# CITY PLAN COMMISSION STAFF REPORT

**Project Name**  
Foley Equipment

**Request**  
CD-CPC-2022-00132  
Rezoning to UR/MPD

# UR DEVELOPMENT PLAN AMMENDMENT & FINAL PLAN FOR FOLEY EQUIPMENT PHASE 2

**1 NORTH ELEVATION**  
1/8" = 1'-0"  
RTR BUILDING

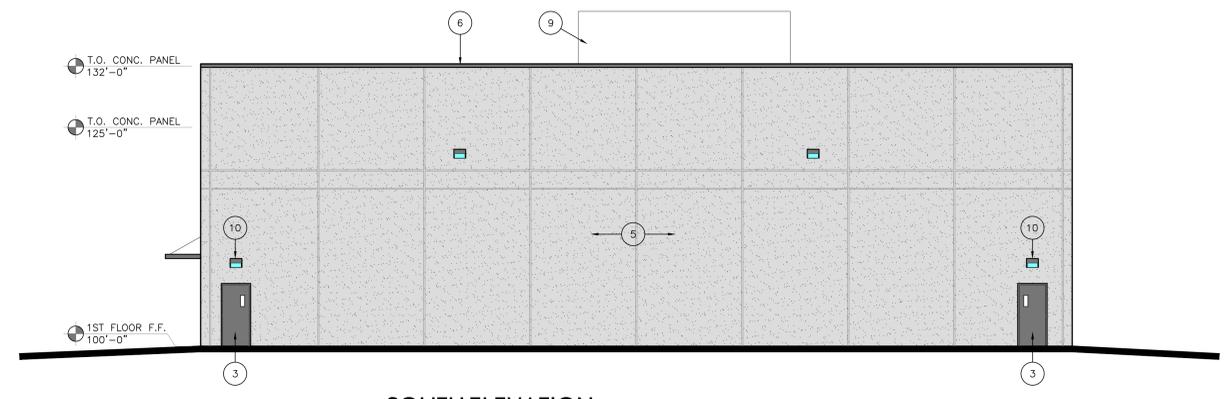
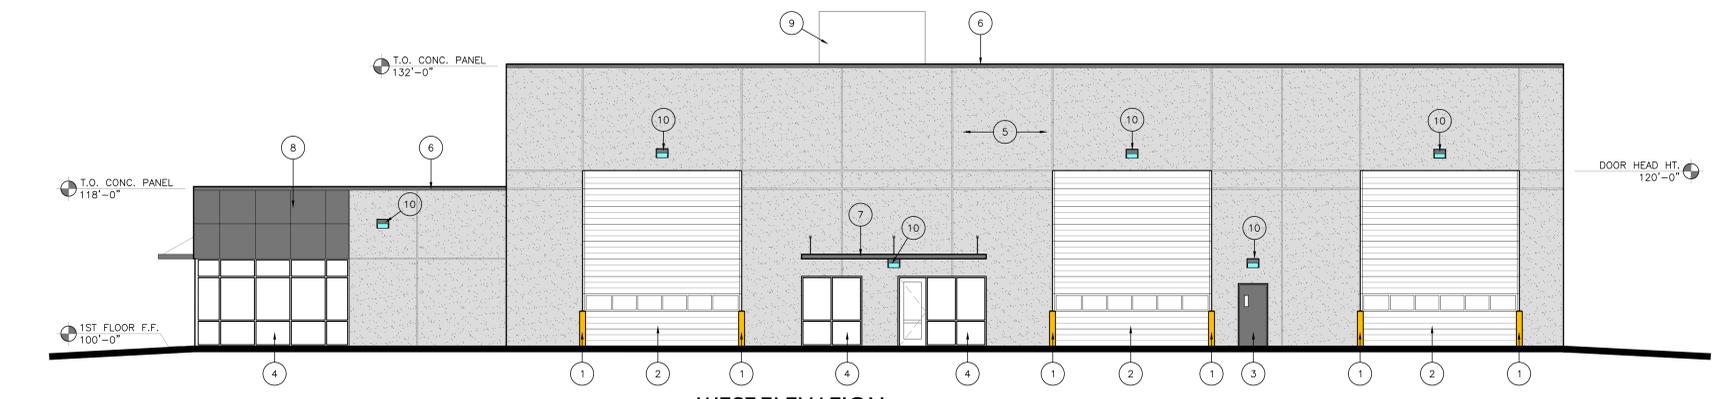
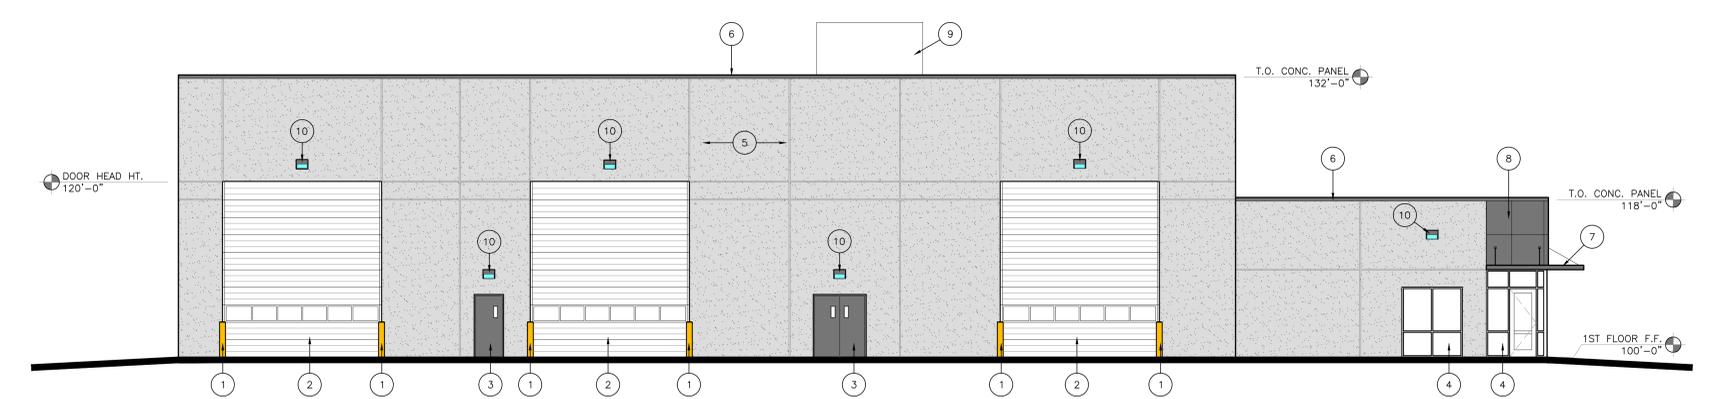
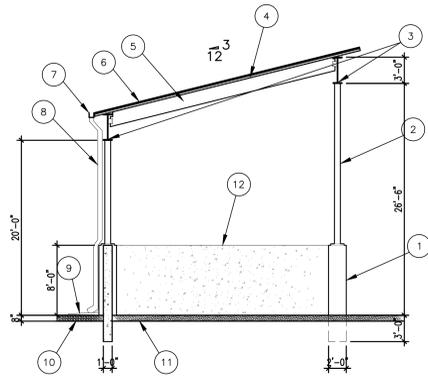
The proposed industrial buildings and uses and permitted and the architectural materials and style match the existing buildings located on this site. The applicant will provide color elevations when they apply for their UR final plan prior to receiving a building permit. The proposed plan is not making any changes to the previously approved landscape plan. The existing landscape plan is primarily focused along the southside of E. 87<sup>th</sup> Street.

7. The applicant shall provide color elevations including details of building materials prior to ordinance request.

**LANDSCAPE PLAN**

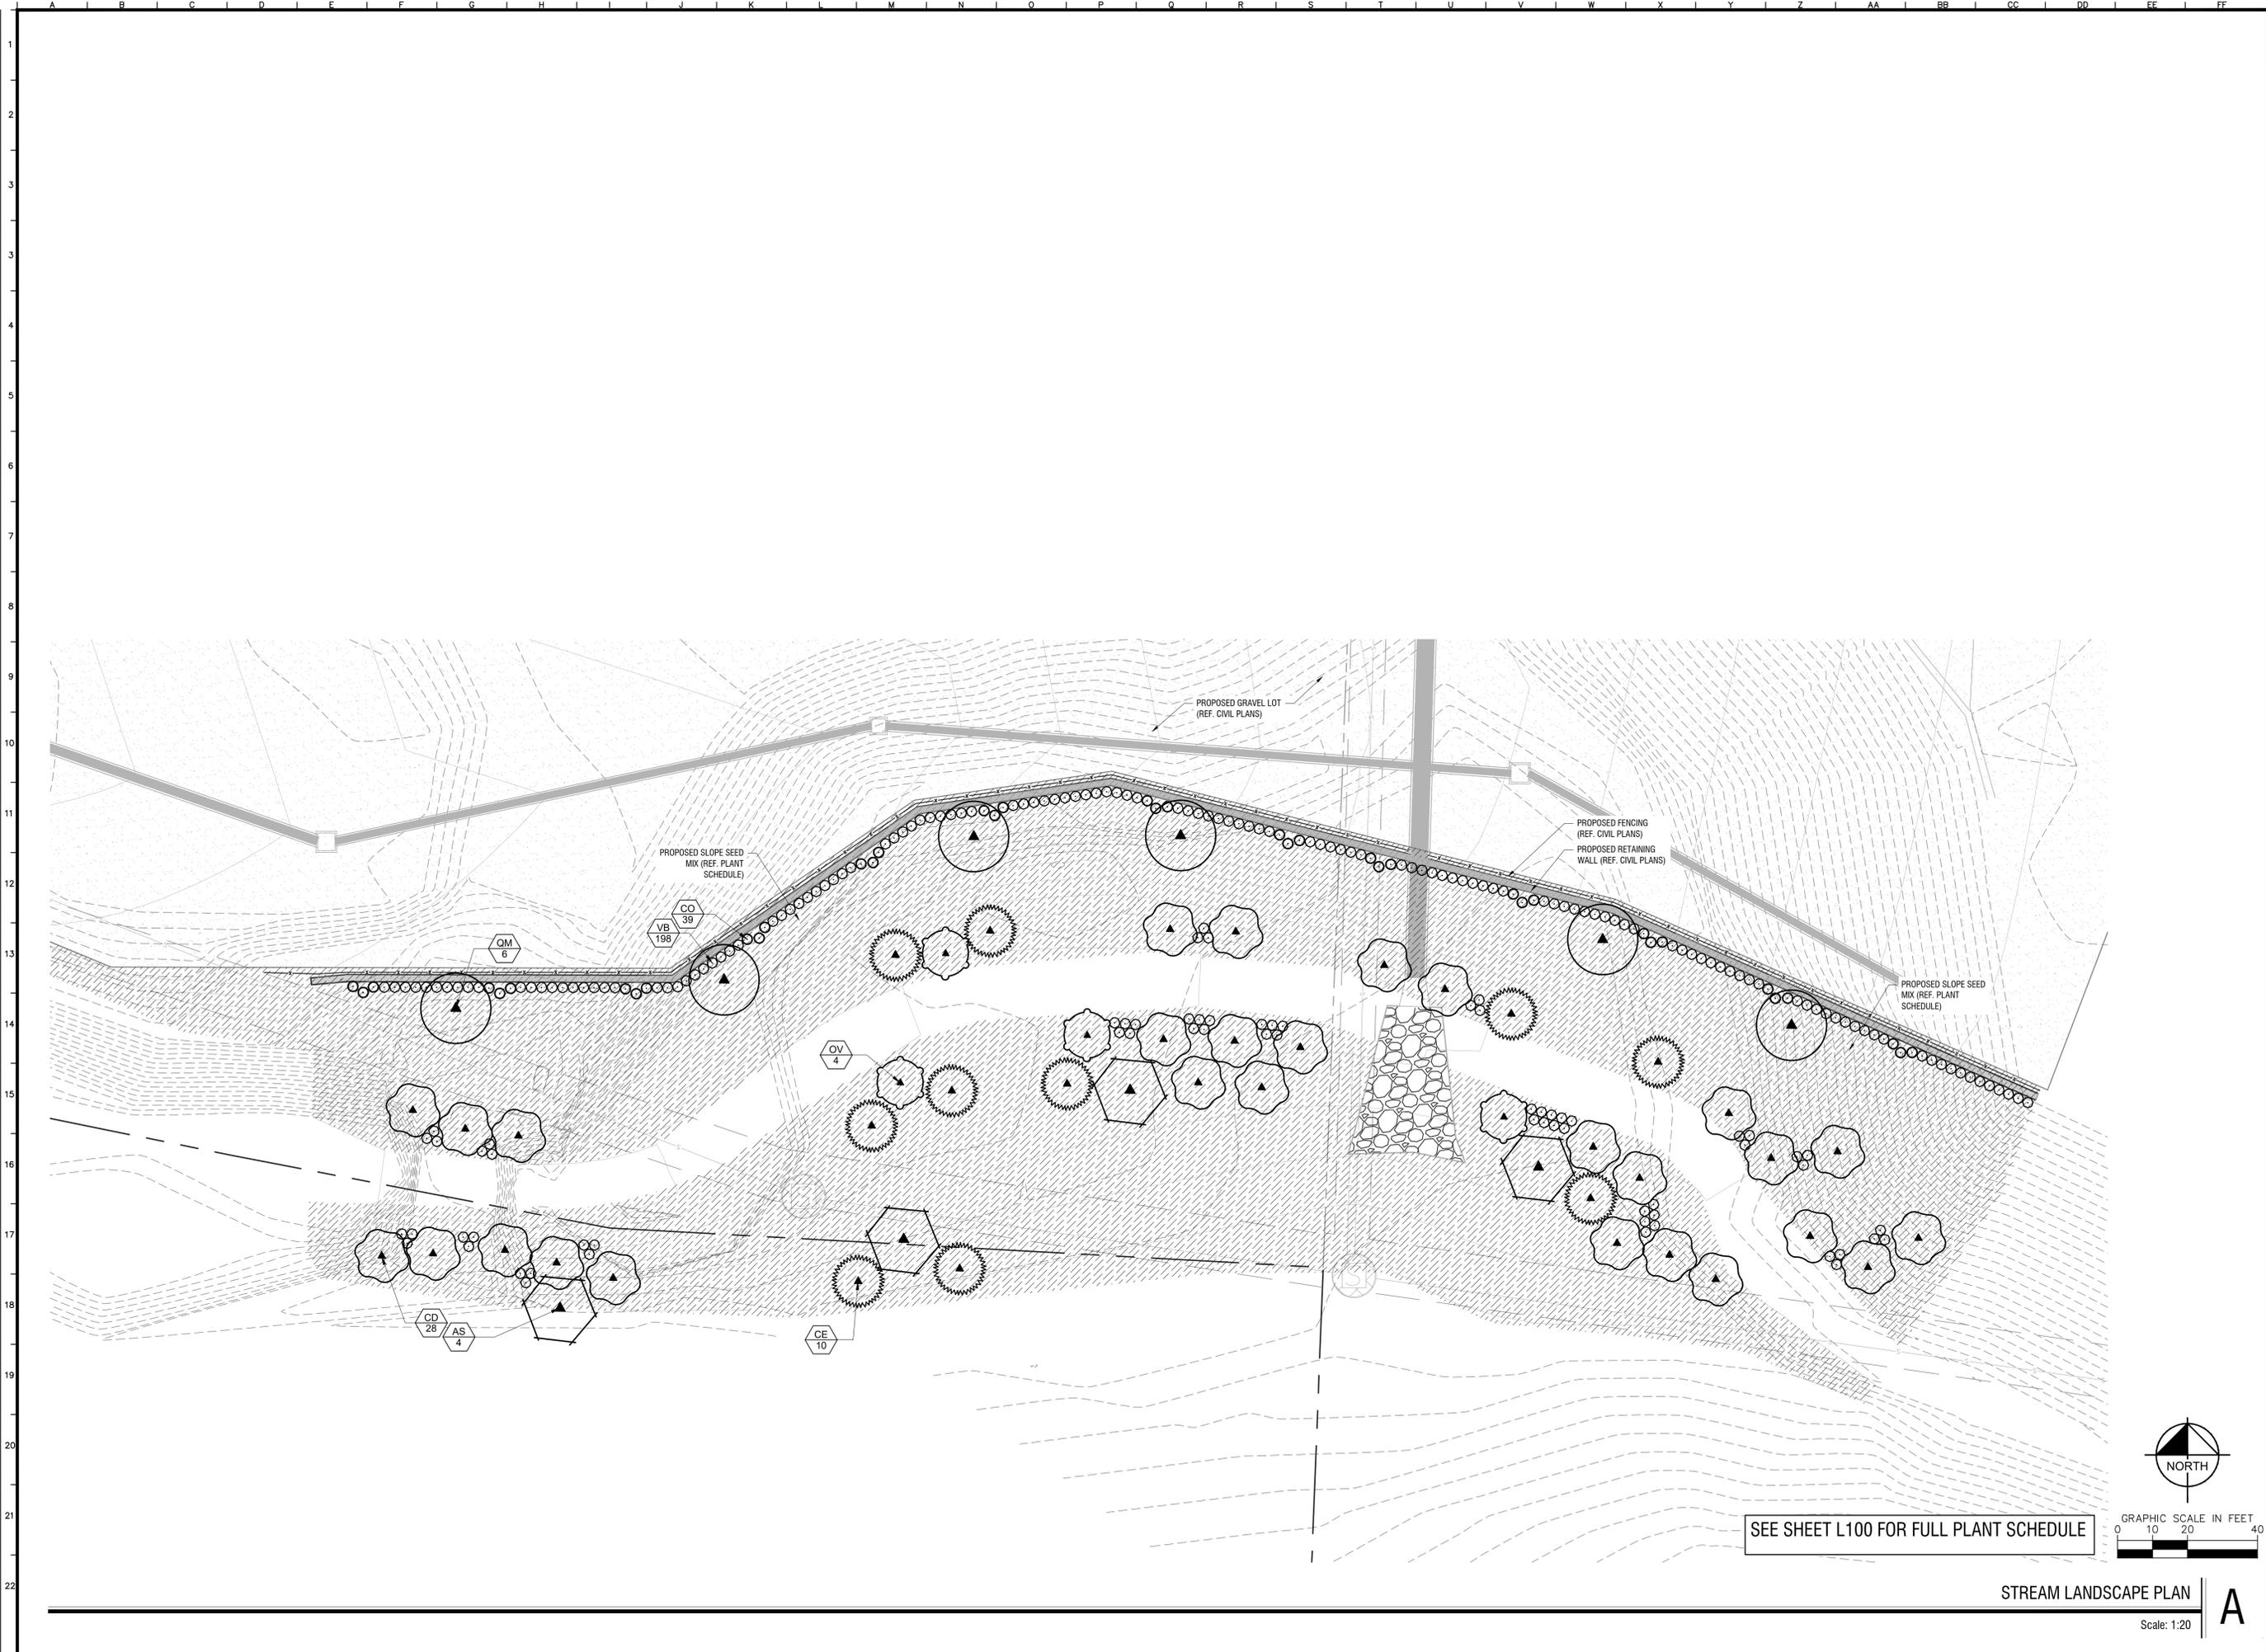
The applicant shall provide consistent screening with shrubs of at least 4' in height along E. 87<sup>th</sup> Street.

5. The developer must include the approved landscape plan with revised plans prior to receiving a building permit.
6. The developer shall secure approval of a UR final plan from Development Management Division staff prior to building permit.
